Service Letter: 438

Date: September 25, 2014

Title: Inspection of Fuselage Frame at Main Gear Attachment

Models: 7EC, 7ECA, 7GCAA, 7GCBC, 7KCAB, 8KCAB and 8GCBC, 1967 and Up

Figure 1, Longeron at Main Gear Attachment

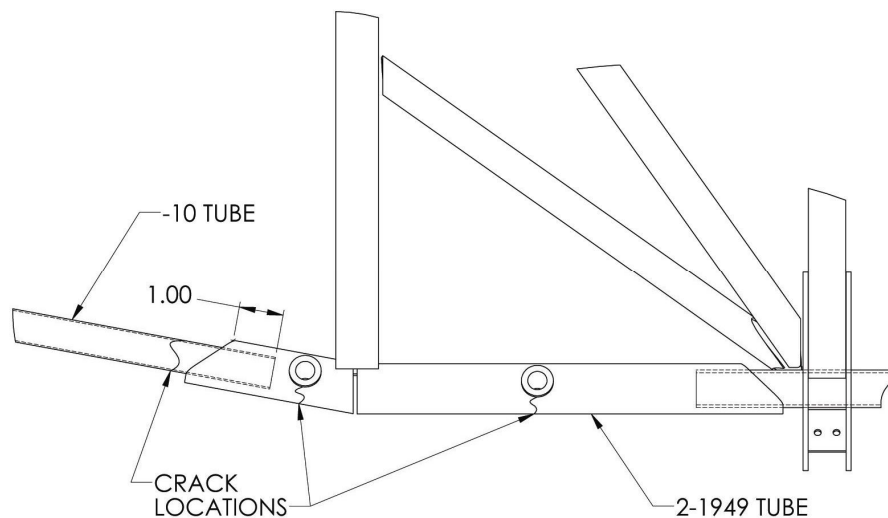
Main gear loads contribute to stress at the u-bolt attach holes and forward longeron; cracks may develop in these areas. Special emphasis should be placed on aircraft having damage history, used for flight training, or operating frequently on unimproved surfaces.

1. Remove belly pan or open lower wraparound. Remove forward metal belly skin (if equipped).
2. Visually inspect left and right main gear longerons as indicated in Figure 1. Removal of upholstery panels may be necessary to facilitate inspection at the aft u-bolt attachment. Cracks typically originate from the attachment holes.

1. Plan an inner-sleeve or outer-sleeve splice per AC 43.13-1B figure 4-37 or 4-38. Cut and remove damaged section of -10 tube.
2. Grind the weld as required to remove -10 tube from 2-1949.
3. Replace removed portion of -10 tube with .035 x Ø.75 4130 Steel Tubing Condition N (AMS-T-6736). Replacement tube must be inserted 1.00 inches into 2-1949 tube (see Figure 1). Effect an inner-sleeve or outer-sleeve splice. Weld per specification CW-1S or other approved method.

Repair per drawing 4-1530, Installation – Gussets, rev. A or later. Weld cracks and gussets per specification CW-1S or other approved method.
